ROSETTA PLASMA CONSORTIUM LANGMUIR PROBE

RPC LAP

RPC LAP Data Sets

ro-a-rpclap-2-ast2-edited-v1.0/CATALOG
ro-a-rpclap-3-ast2-calib-v1.0/CATALOG
RPCLAP_INST.CAT

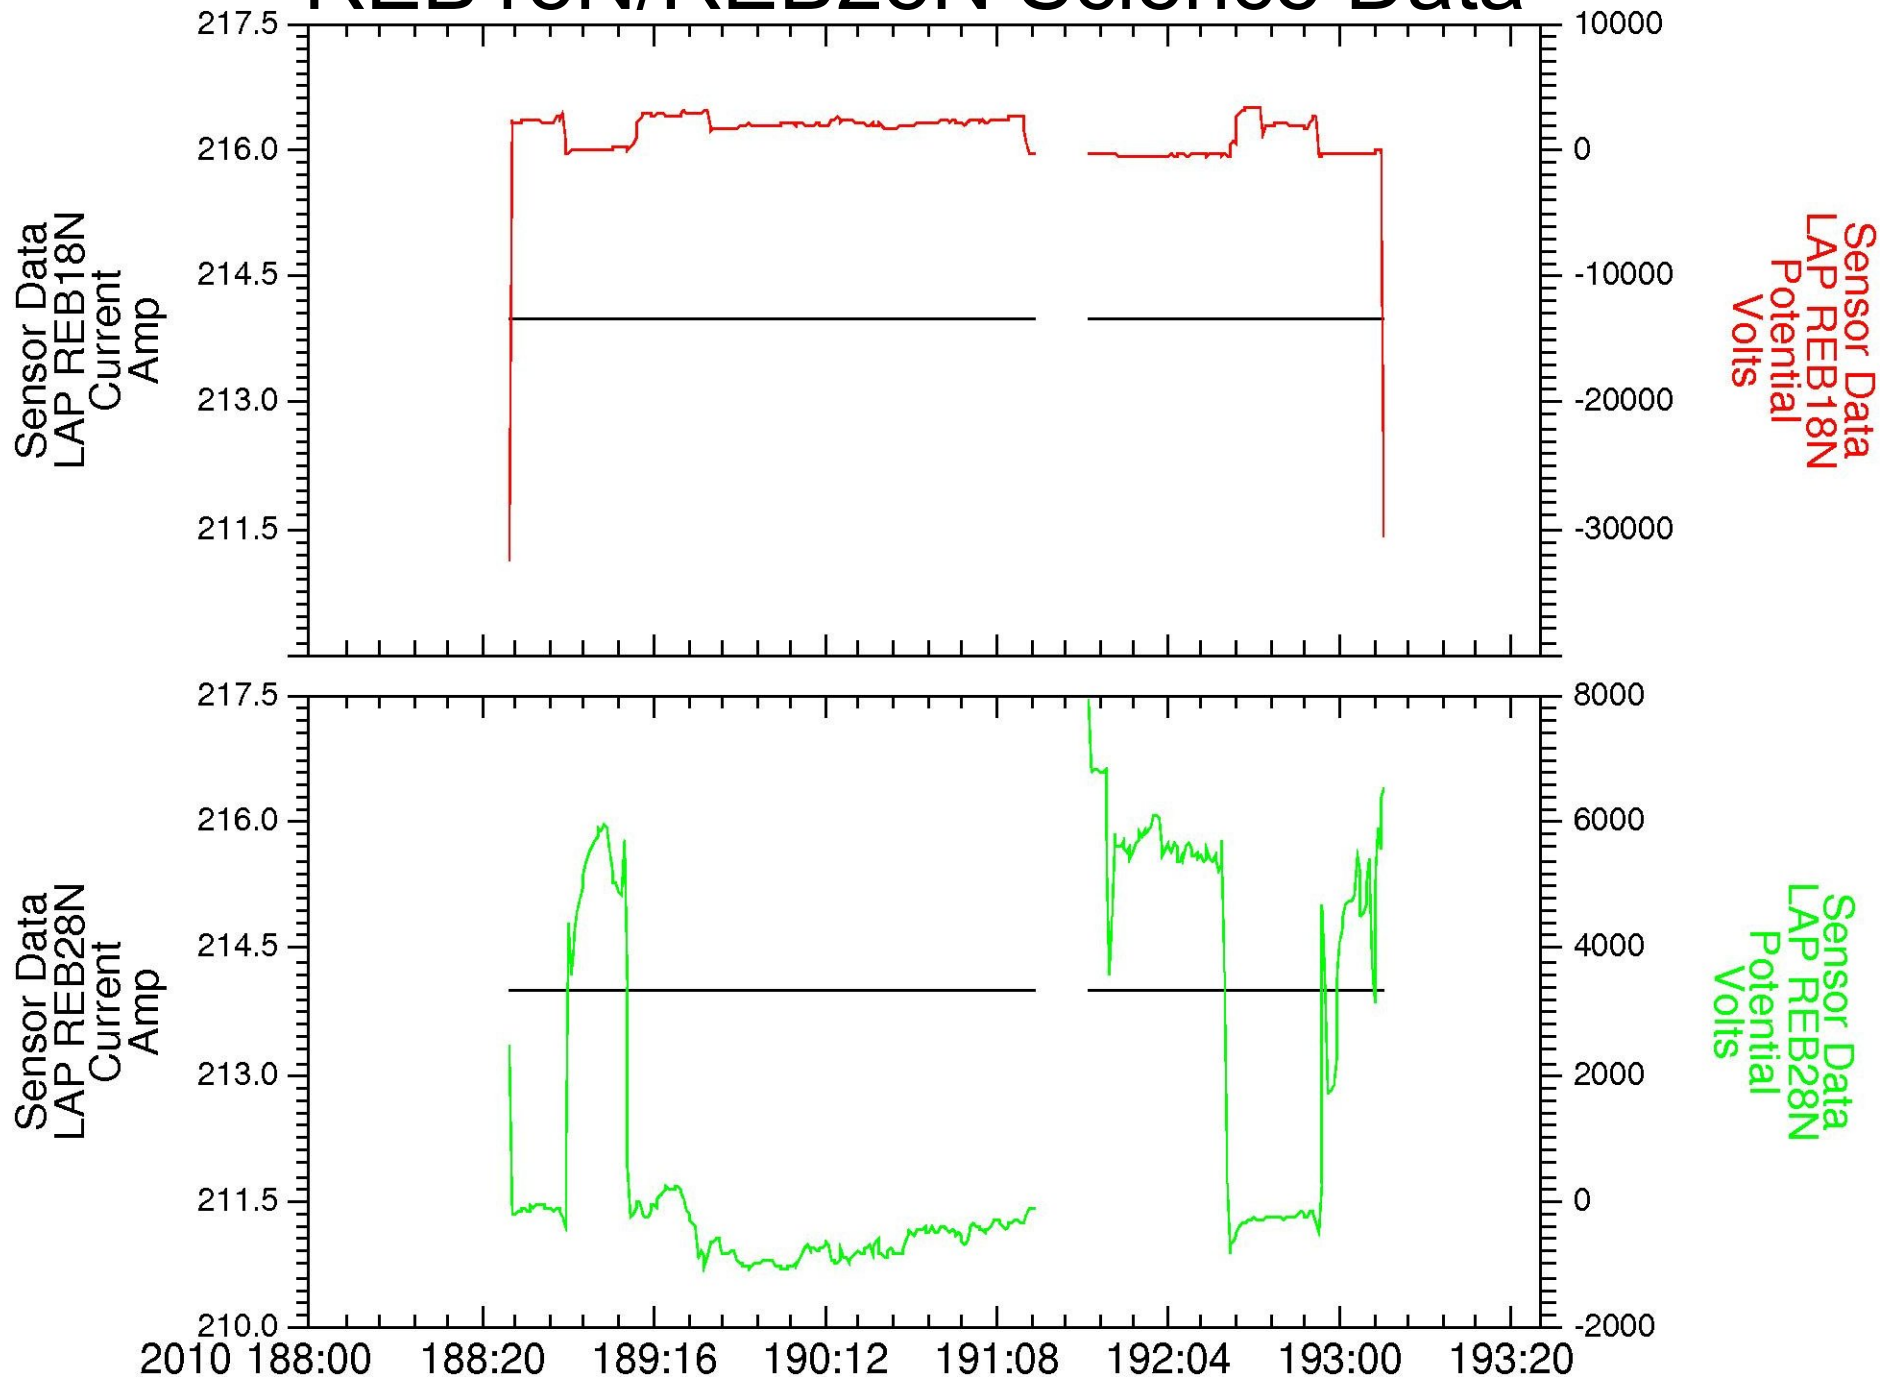
- ▶ References to ERIKSSON2007A and ERIKSSON2008A do not exist in the DOCUMENTS directory as stated.
- ▶ Coordinate X on the Probe 2 listed in the LAP Sensor Locations table is incorrect. This value should be negative (or else boom 2 pokes through the spacecraft). The value of the X coordinate in this document needs to be corrected in earlier versions as well.

ro-a-rpclap-2-ast2-edited-v1.0/data
ro-a-rpclap-3-ast2-calib-v1.0/data
R/C EB 1/2 8N Science Data

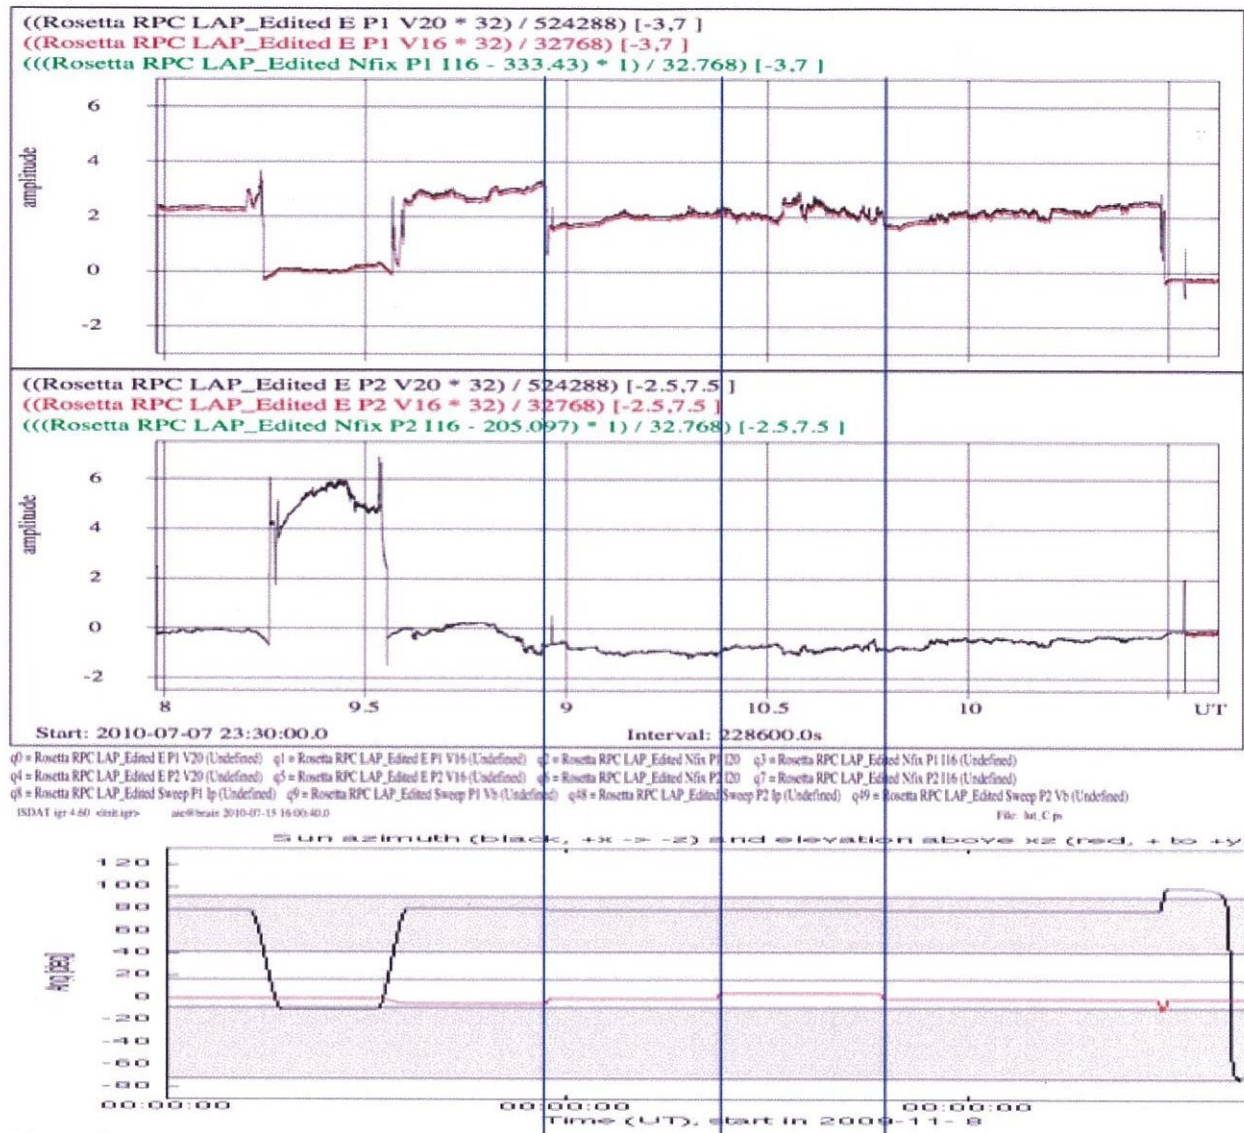
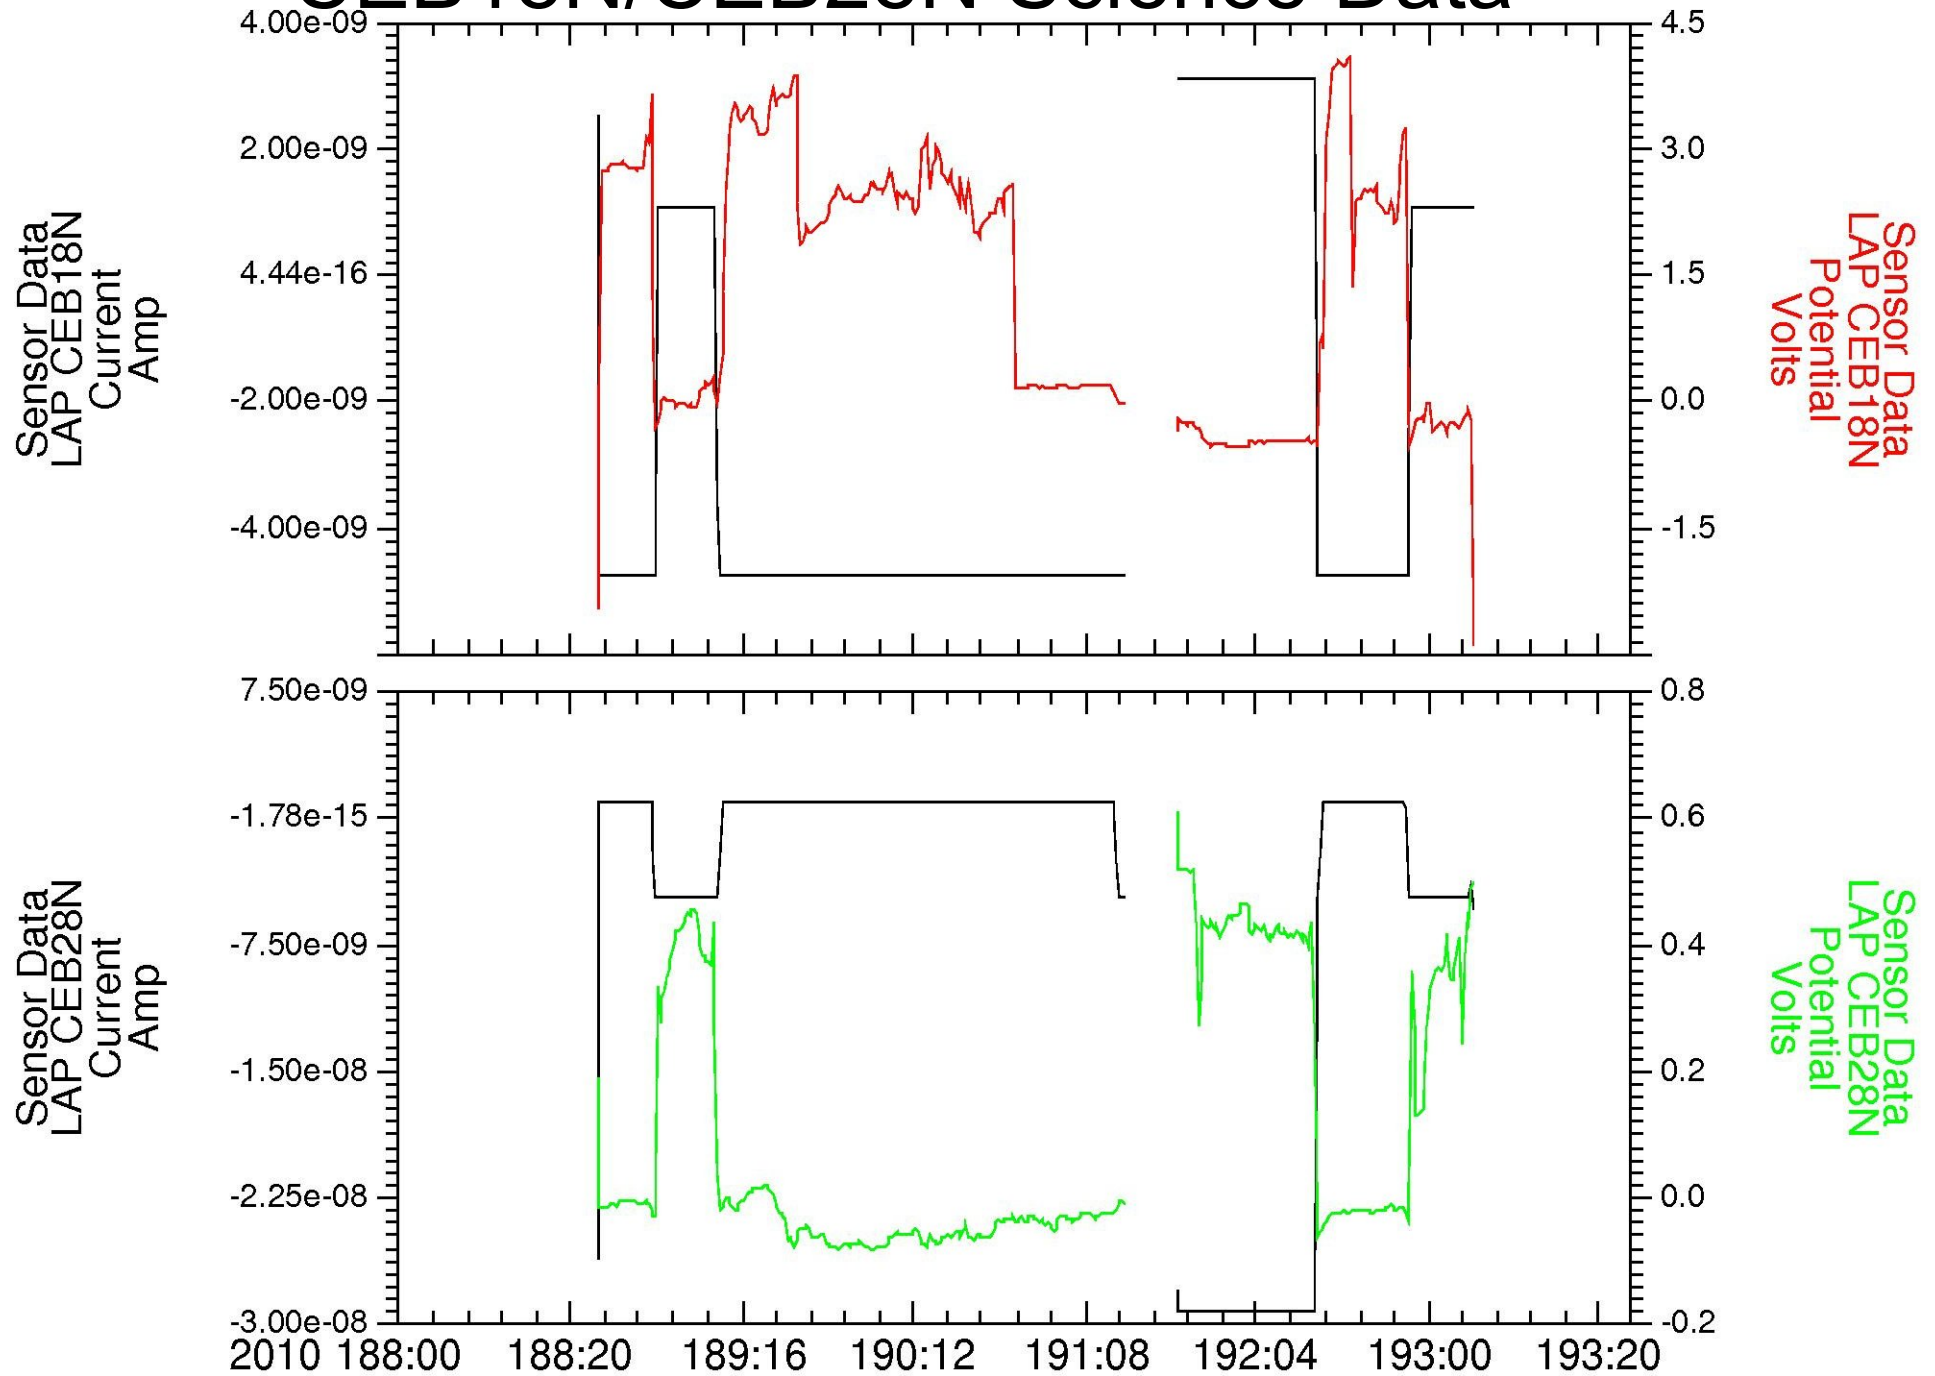
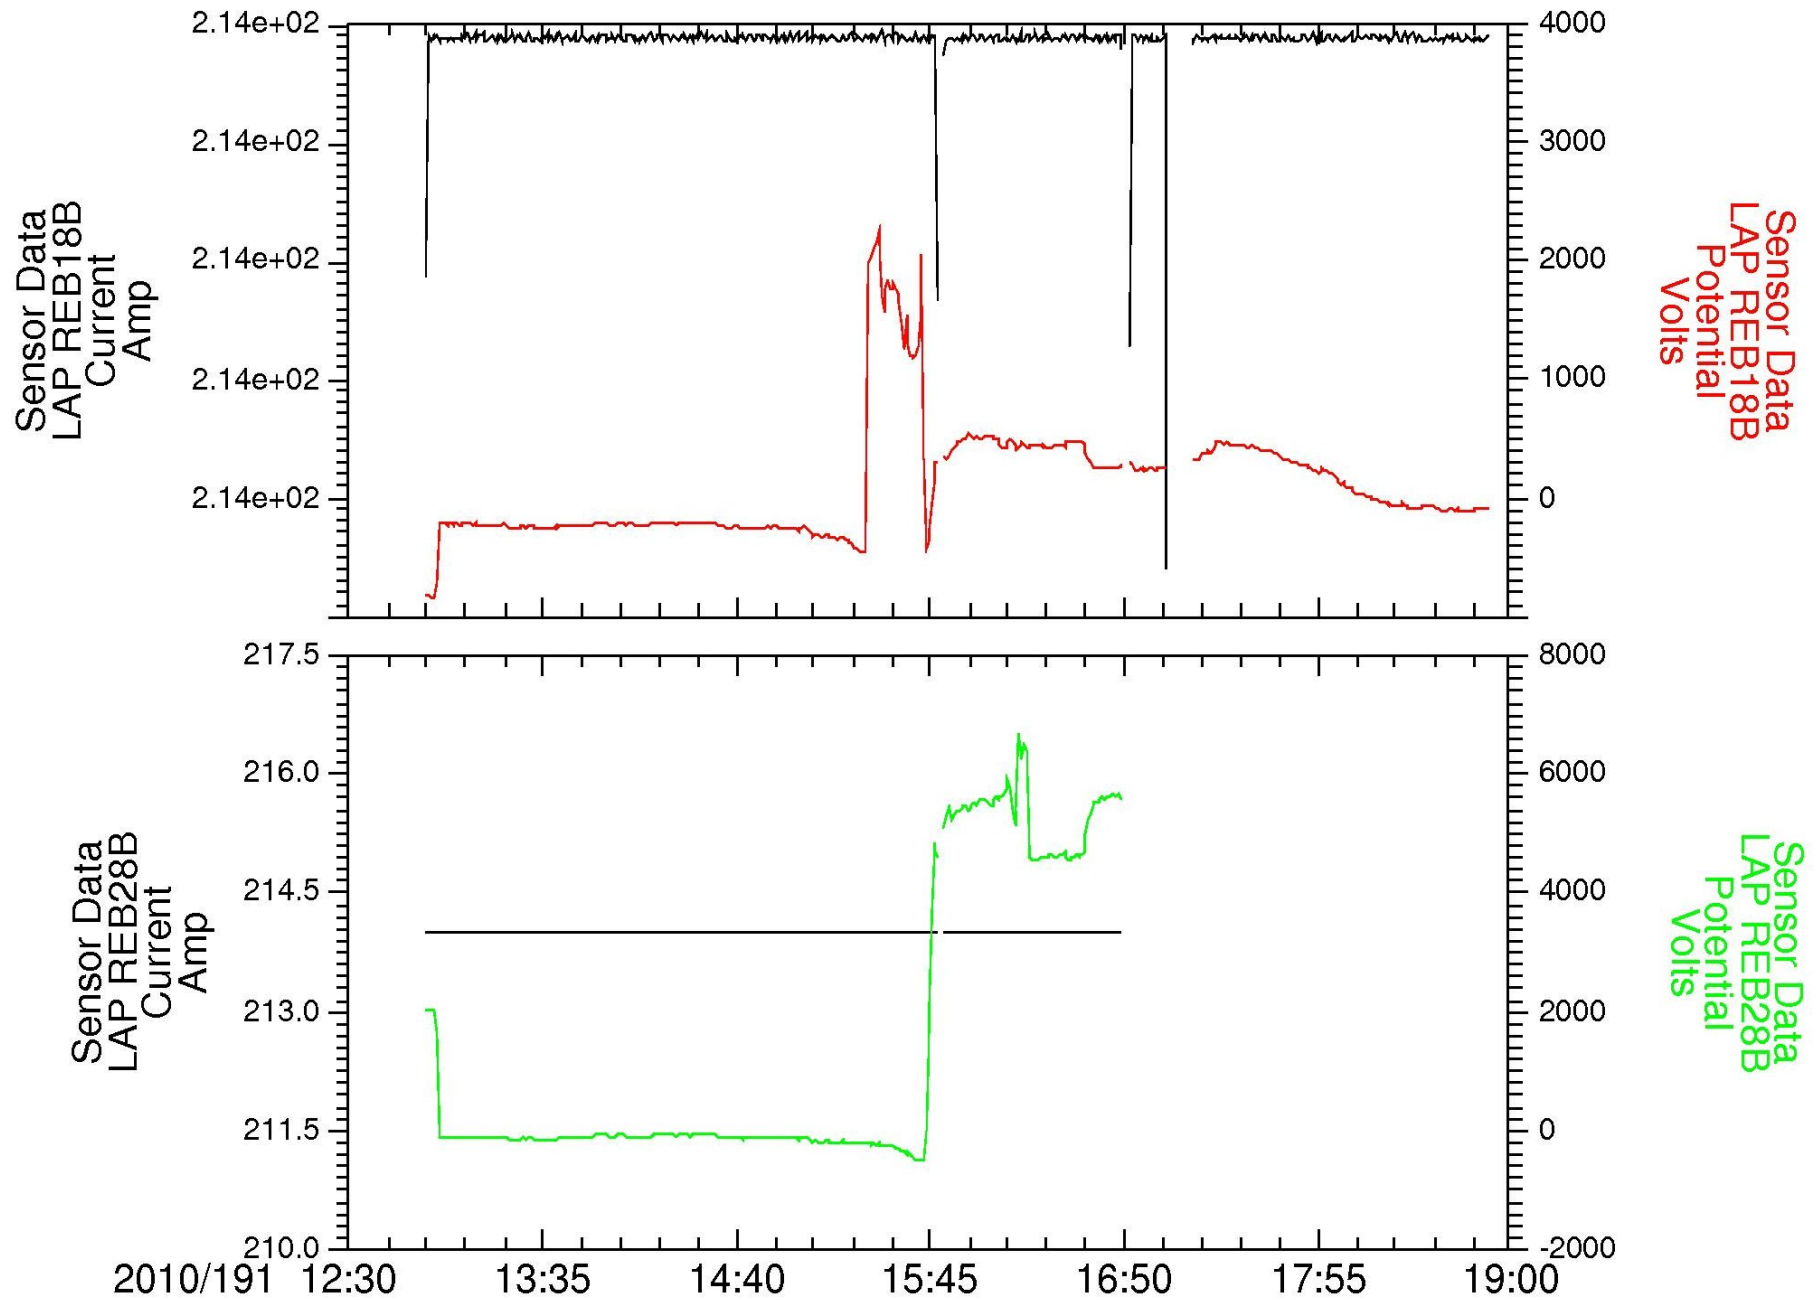
- ▶ Both edited and calibrated science data were examined and they both replicate the shape of the voltage as shown in the flight report.
- ▶ Amplitude voltage numbers of the flight report do not agree with the edited data, but do agree with the calibrated.
- ▶ It is not clear why the edited currents do not replicate the shape of the calibrated currents. The flight report does not seem to contain this information.
